UNITED STATES PATENT AND TRADEMARK OFFICE

APPLICATION NO.	FILING DATE	FIRST NAMED INVENTOR	ATTORNEY DOCKET NO.	CONFIRMATION NO.
09/476,521	01/03/2000	Herbert Gropp	RUM212	7964
7590	03/08/2005		EXAMINER	
Horst M. Kasper 13 Forest Drive Warren, NJ 07059			LUONG, VINH	
			ART UNIT	PAPER NUMBER
			3682

Office Action Summary

Fig. 1

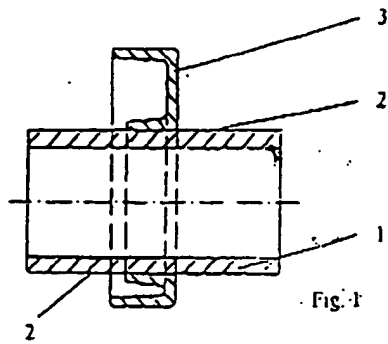
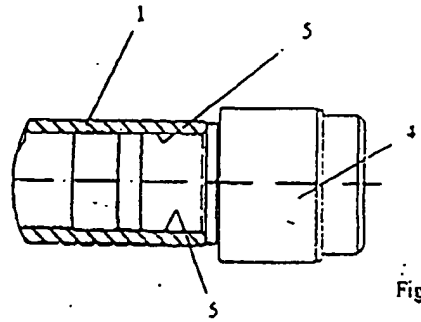
The original drawings show only two coatings, *i.e.*, the first and second coatings 2 and 5, the pipe 1 and the cams 3. See page 6 of the original specification and original claims 1-5.

First, lines 17-20 of claim 9 claim a *third* compression joint, and a *third* crystalline phosphate coating. Similarly, lines 12-16 of claim 10 claim a third longitudinal compression joint and a third joint-stable surface coating. However, the original drawings (Figs. 1-3) show

only two coatings 2 and 5 as described in the original specification. Claims 9 and 10 now claim three coatings as evidenced by the term “a *third* crystalline phosphate coating” or “a third joint-stable surface coating.” The third crystalline phosphate coating or the third stable surface coating is unsupported by the record as filed.

Fig. 3

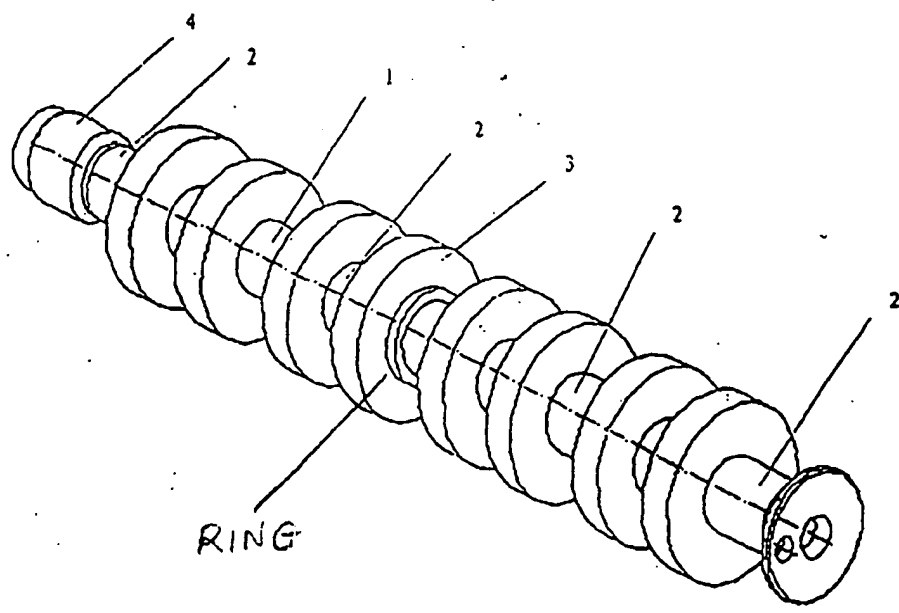
(b) New Fig. 3 introduces new matter, such as, the deletion of a ring (unnumbered, see Attachment attached). The original Fig. 3 shows the ring located adjacent to the cam 3, however, new Fig. 3 now does not show such ring. See *Twin Disc v. United States*, 231 USPQ 417, 435 (US Cls. Ct. 1986)(new matter by deletion).
